CITY OF PALM SPRINGS

MEMORANDUM

Subject: EPSTEIN GLOBAL FOR REVISIONS TO A MINOR ARCHITECTURAL APPLICATION FOR A REMODEL OF AN EXISTING CANNABIS DISPENSARY LOCATED AT 4765 EAST RAMON ROAD, ZONE M-1 (CASE 3.4280 MAA) (RB)

SHEET TITLE:
PLANTING PLAN

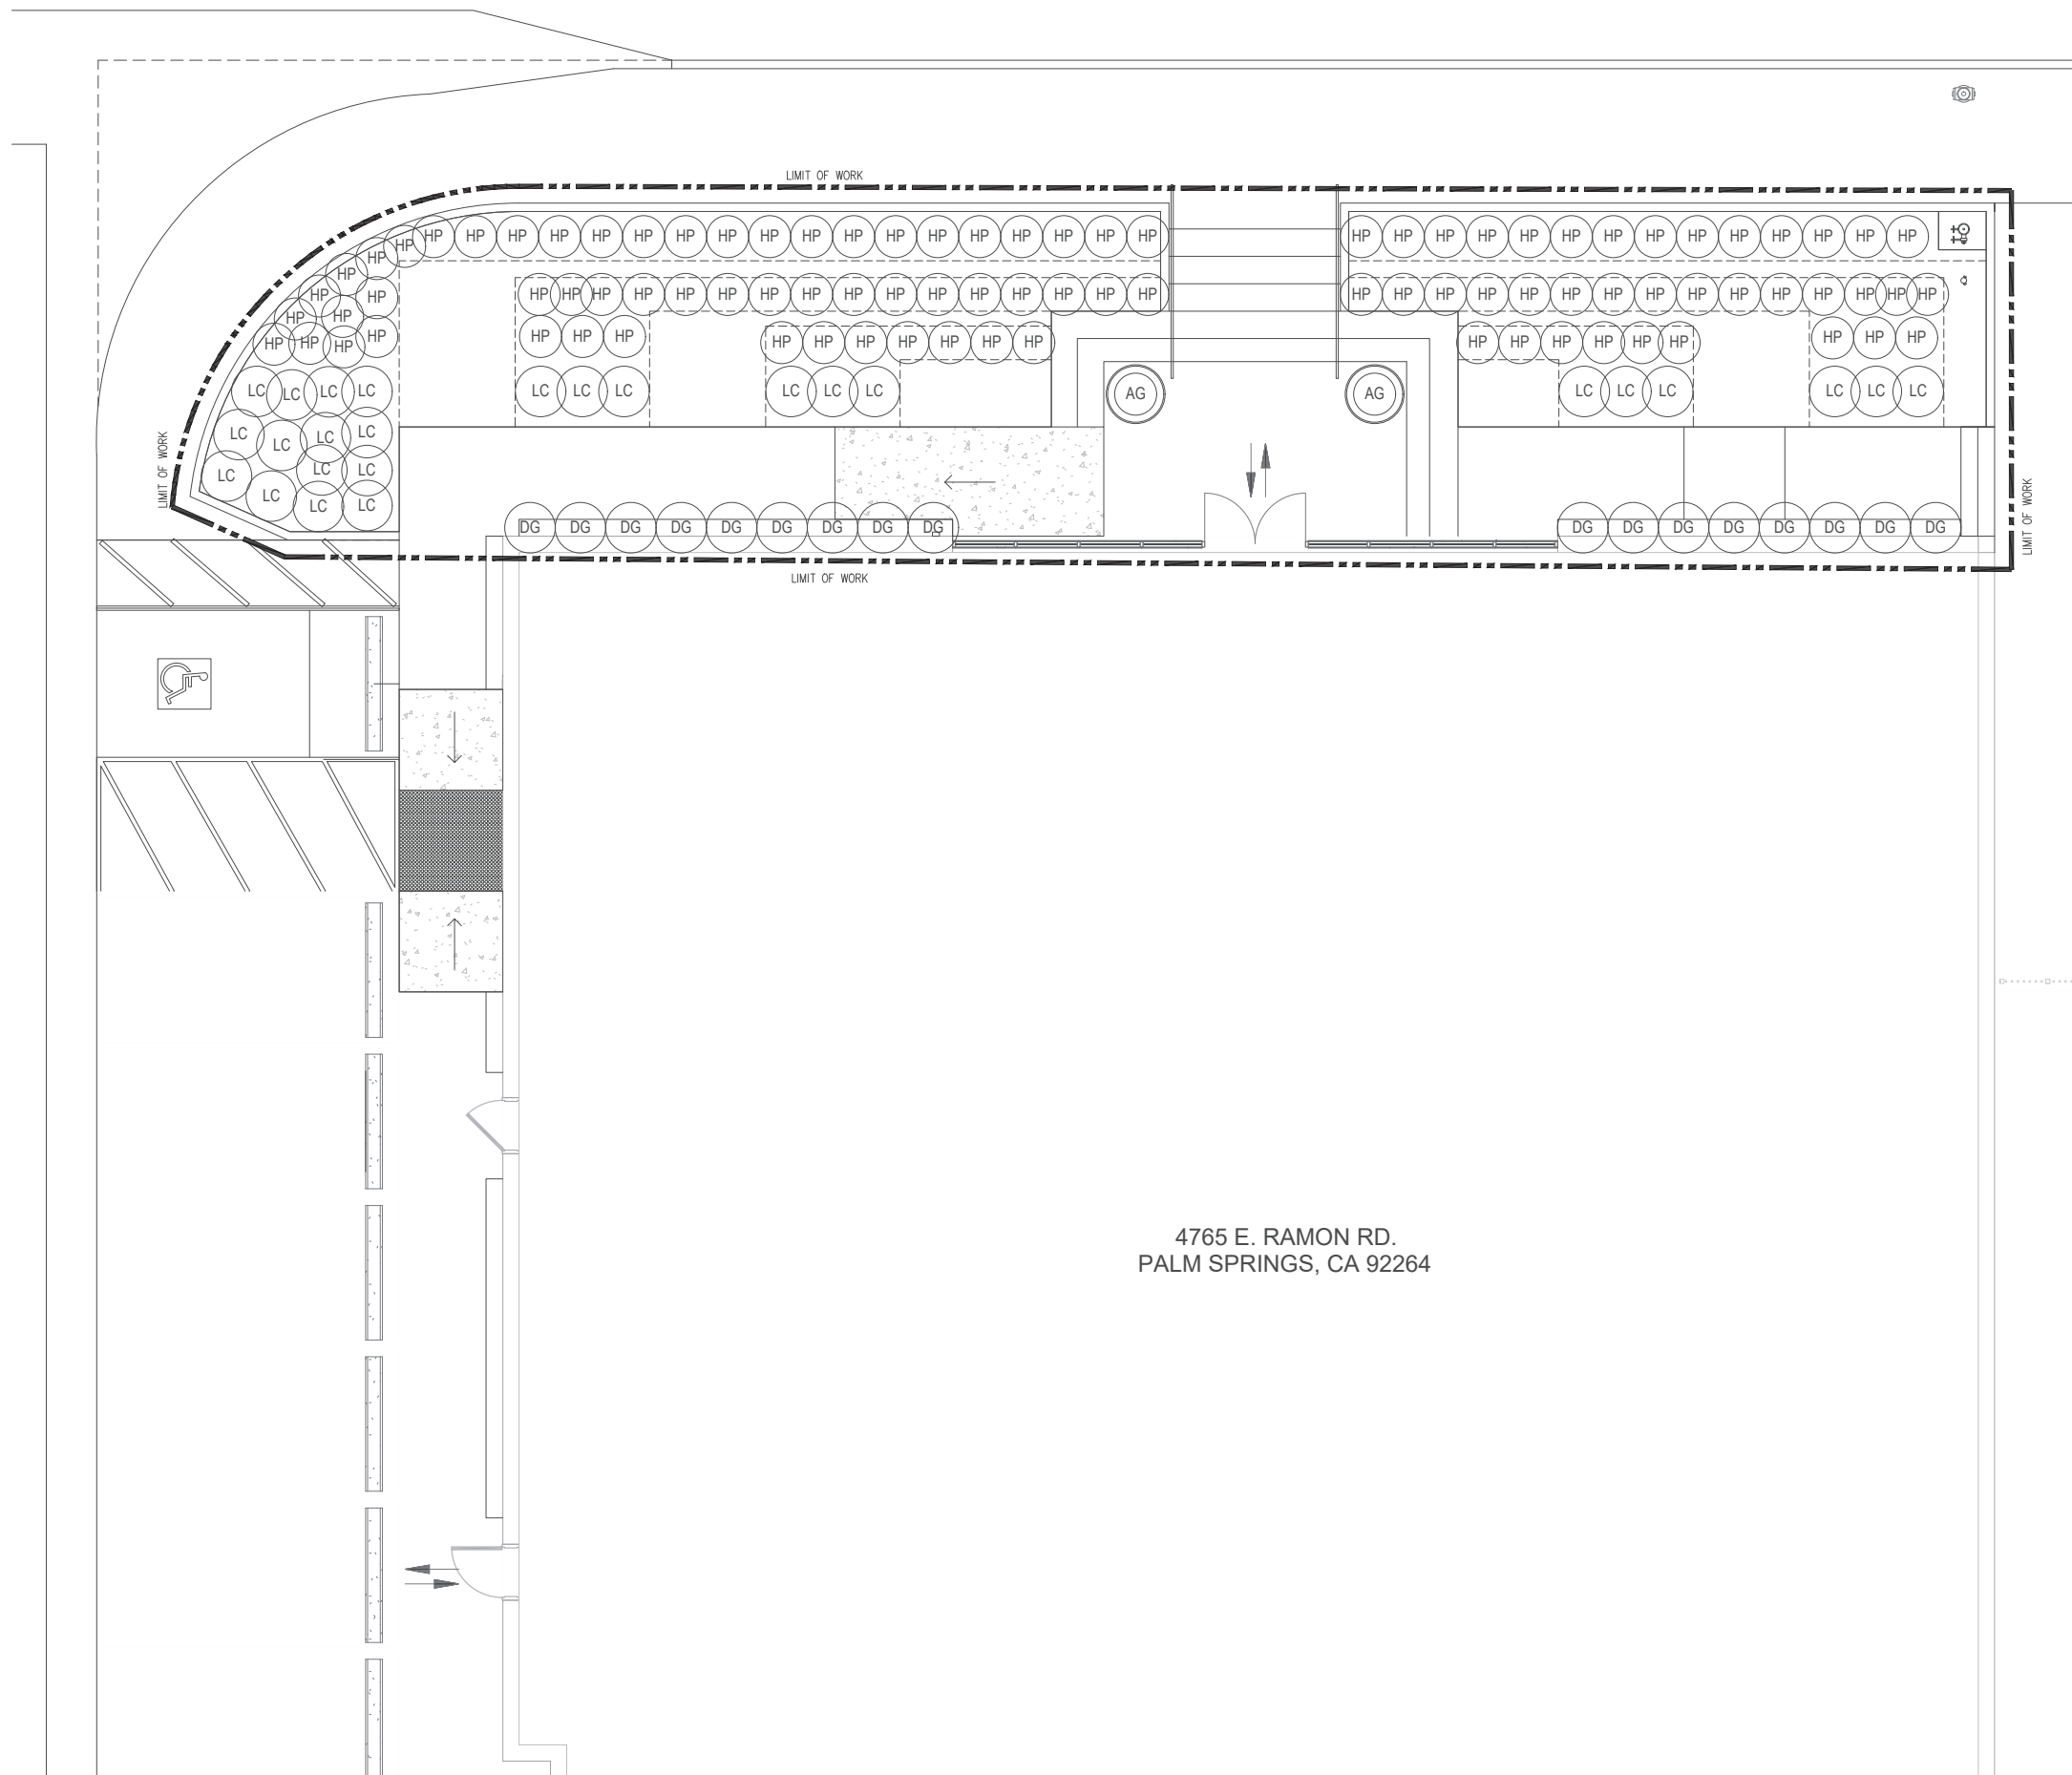
Member Lockyer thinks this is the perfect opportunity to improve the landscaping which has fallen to disarray.

Member Doczi agreed with Member Lockyer, noting that this building is visible when exiting the airport and such a prominent location would benefit from landscape improvements.

1. Lighting plan to include the building exterior and landscape.
2. Final landscape plan shall be submitted for ARC review.
3. Details of handrails for front entrance stairs and accessible ramp.
4. Details of entrance planter repair and repainting.

#	Additional Review Item	Proposed Revision
1	An updated landscape plan with additional plant materials.	The revised landscape and hardscape plans provide an enhanced visual and pedestrian experience of the front (Ramon) entry. Handrails will be installed. A linear landscape design that includes Red Yuccas and Blue Rangers, is proposed within the planters. Two new pots with Agaves will flank the front entry platform. Fortnight Lilies will be planted against the building. All planter areas will include new ½"-1" pebble rock.
2	A lighting plan with fixture details.	New fully shielded fixtures are proposed to replace existing wall packs.
3	<p>Enhancements to the building facades, which will be limited to the following at the recommendation of the ARC:</p> <p>Front elevation (facing Ramon): Treatment of the boarded-up clerestory windows, replacement of existing light fixtures with decorative fixtures (while compliant with the outdoor lighting code), fascia treatment, principal building color and accent color, enhancement or replacement of awning.</p> <p>West elevation (facing Williams): Treatment of the boarded windows (re-stucco or repair façade so that patchwork is less visible), paint</p>	<p>The applicant will remove or bury all exterior conduit and all existing stucco will be removed, repaired and painted light gray on all sides of the building. The building trim and fascia will be replaced as needed.</p> <p>A new awning that is dark blue will replace existing green awning. In addition to the lighting and stucco repair/replacement/paint mentioned above, the front boarded-up clerestory windows will be removed, patched with new stucco and painted light gray.</p> <p>In addition to the lighting and stucco repair/replacement/paint mentioned above, a boarded window will be patched with stucco.</p>

1 HANDRAIL AT STAIRS
SCALE: 1"=1'-0"

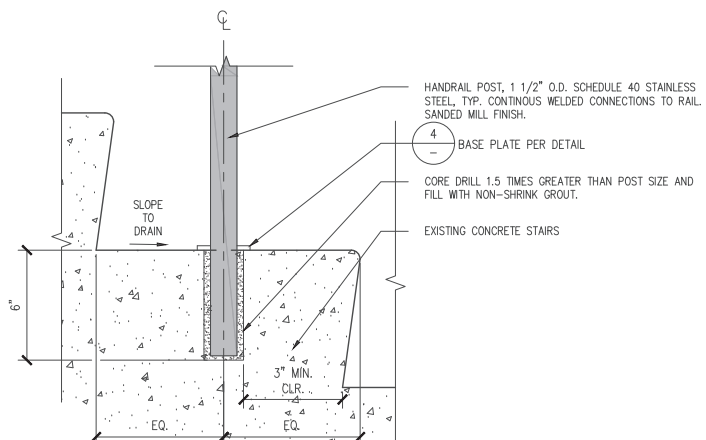
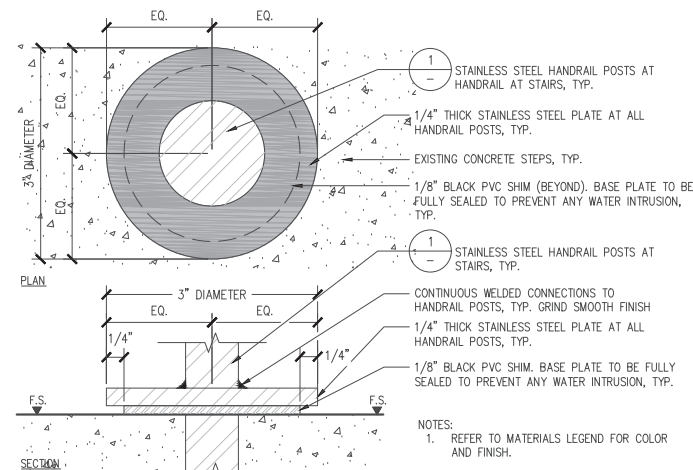
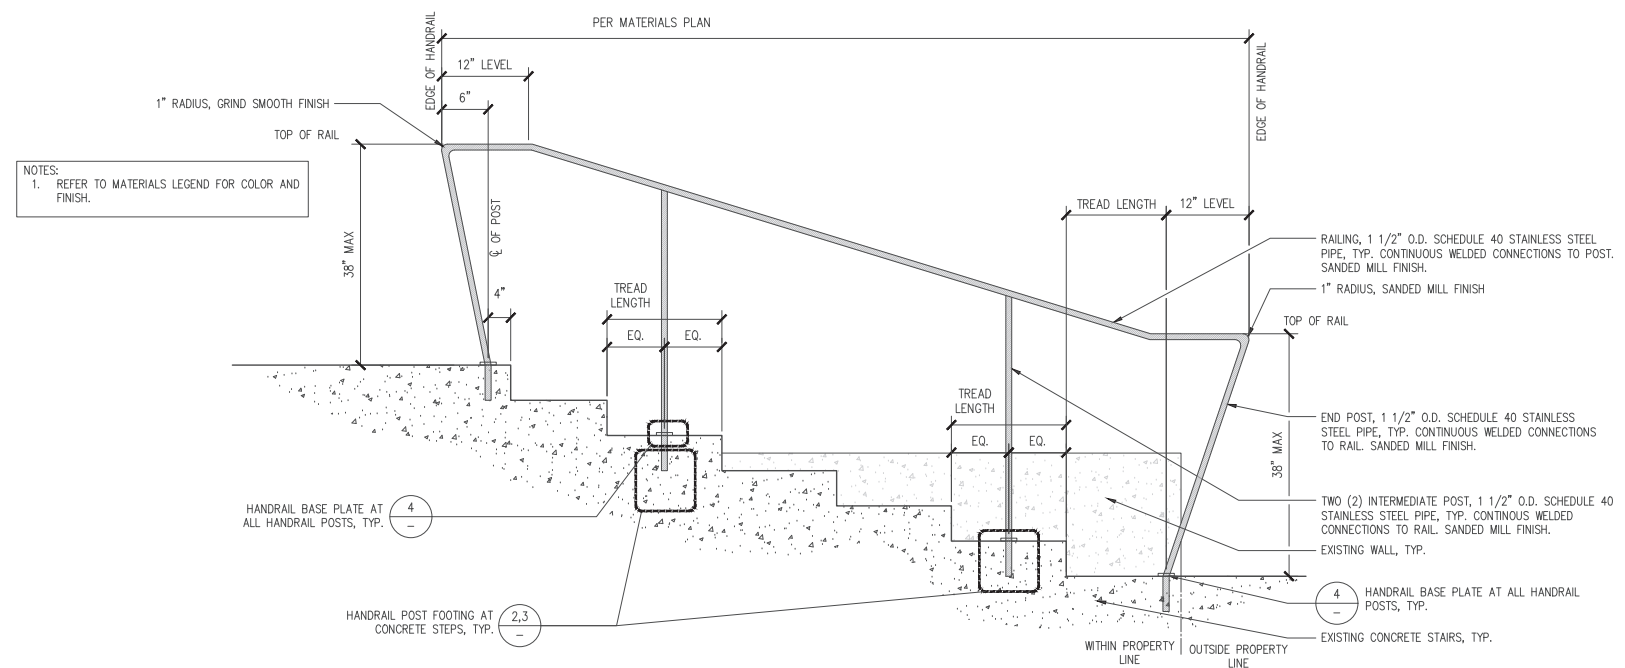
Chair Jakway noted the Building Code will require a handrail on the flank of stairs.

KEY	ITEM	MANUFACTURER/MATERIAL	COLOR	FINISH	DETAIL(S)	REMARKS
(SF-1)	NEW HANDRAILS AT EXISTING STAIRS	MATERIAL: STAINLESS STEEL	-	MATTE FINISH	1-4 / L1.03	
(SF-2)	PLANTER POT	MANUF: OLD TOWN FIBERGLASS MODEL: KB3813 - 38" O.D.	BLUE	MATTE FINISH	3 / L1.04

2 EAST ELEVATION
SCALE: 1/4" = 1'-0"

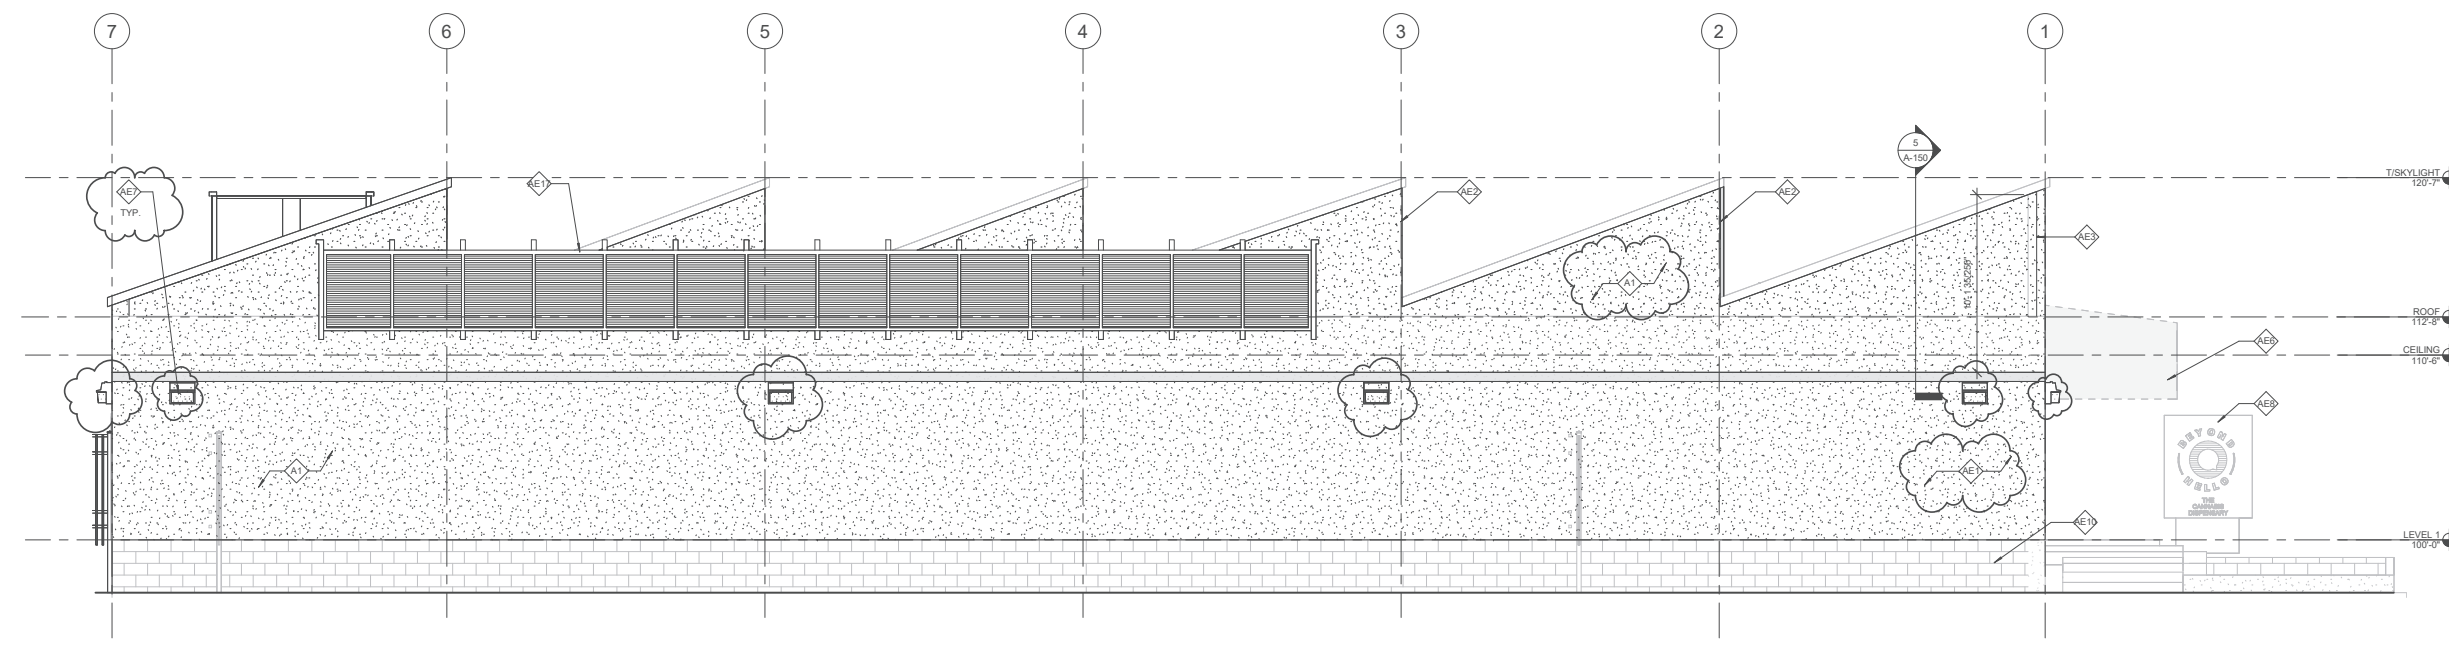
- East elevation: Replacement of existing light fixtures with decorative fixtures (while compliant with the outdoor lighting code), signage treatment/placement, conceal exposed conduit/piping.

#	Additional Review Item	Proposed Revision
	treatment of exterior doors for consistency, conceal exposed conduit/piping on building exterior, signage treatment/placement (e.g., parking signage on building façade).	
	East elevation: Replacement of existing light fixtures with decorative fixtures (while compliant with the outdoor lighting code), signage treatment/placement, conceal exposed conduit/piping.	See above for updates to the lighting, conduit and stucco that are also proposed on this elevation.

1 SOUTH ELEVATION
 SCALE: 1/4" = 1'-0"

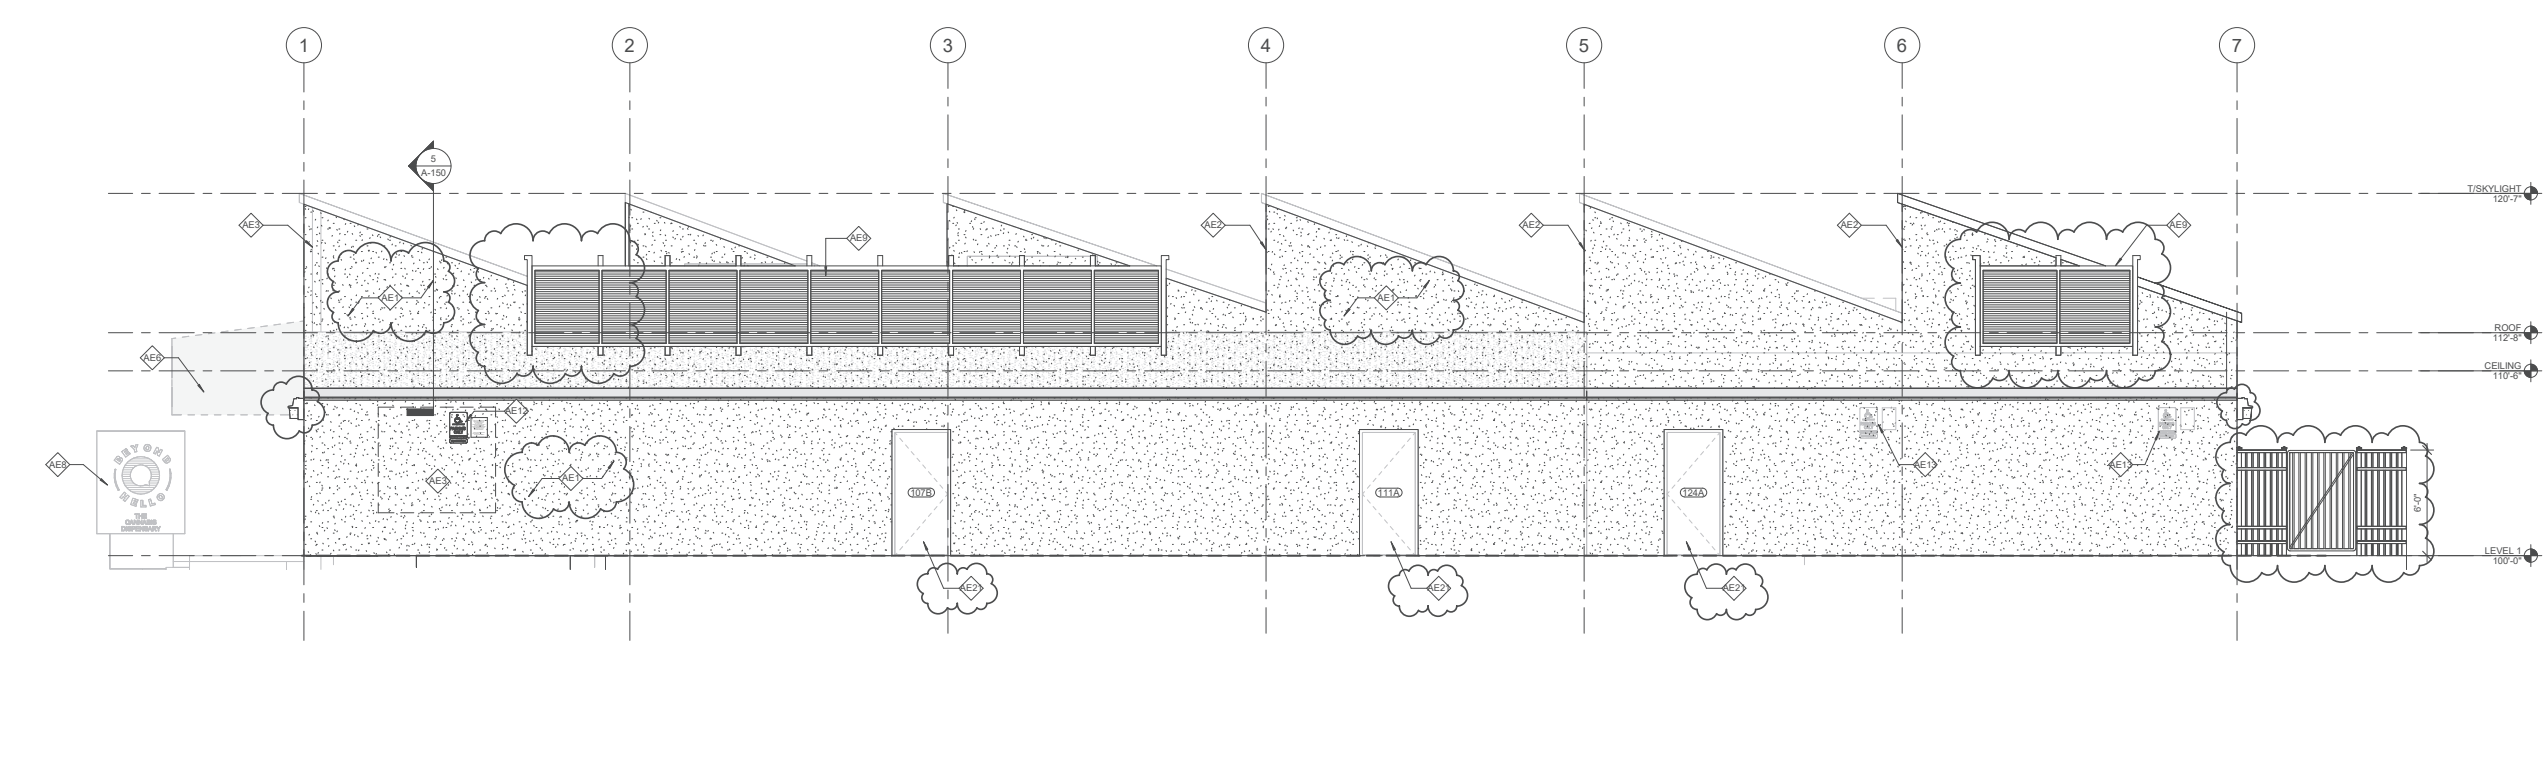
In addition, the applicant intends to continue the stucco repair on the south elevation by patching an existing door with stucco and painting to match the rest of the building.
